Proposal for a Supplement to the 01 series of amendments to UN Regulation No. 148 and to the 06, 07, 08 and 09 series of amendments to UN Regulation No. 48

Submitted by the expert from the International Automotive Lighting and Light-Signalling Expert Group *

The text reproduced below was prepared by the expert from the International Automotive Lighting and Light-Signalling Expert Group (GTB) with the aim to introduce reversing projections. This revised proposal is based on document ECE/TRANS/WP.29/GRE/2024/20 as amended by informal document GRE-91-25. The modifications to the existing text of the UN Regulation are marked in bold for new or strikethrough for deleted characters.

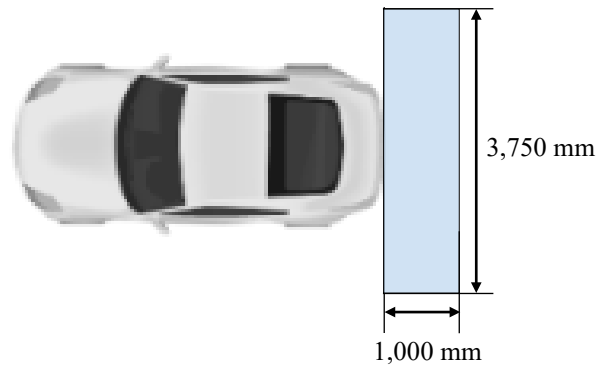
- 6.27.5.1. The lateral distance from the outer edge of the projection with respect to the longitudinal plane of the vehicle shall not be more than 1,875 mm.
The longitudinal distance from the farthest edge of the projection shall not be more than 3,000 mm from the backward extreme outer edge of the vehicle (see figure below).**

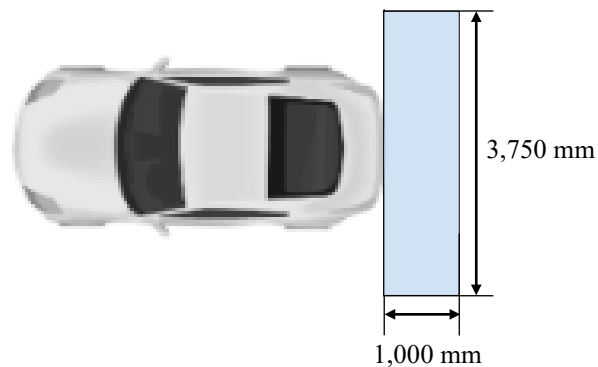
- “6.28. Reversing projection
- 6.28.1. Presence
- Optional
- 6.28.2. Number
- One or two reversing projection(s).
- The reversing projector(s) shall be type approved according to the 01 or subsequent series of amendments to UN Regulation No. 148.
- 6.28.3. Arrangement
- Such that the provisions of paragraphs 6.28.5., 6.28.6. and 6.28.9. are fulfilled.
- 6.28.4. Position
- Such that the provisions of paragraphs 6.28.5., 6.28.6. and 6.28.9. are fulfilled.
- 6.28.5. Projection area
- 6.28.5.1. The lateral distance from the outer edge of the projection with respect to the longitudinal plane of the vehicle shall not be more than 1,875 mm.
The longitudinal distance from the farthest edge of the projection shall not be more than 3,000 mm from the backward extreme outer edge of the vehicle (see figure below).

- 6.28.5.2.** The patterns of the reversing projections shall start with their closest edge within a rectangle, symmetrical to the median longitudinal plane and adjacent to the extreme outer edge of the vehicle a width of 1,000 mm and a length of 3,750 mm (see figure below).
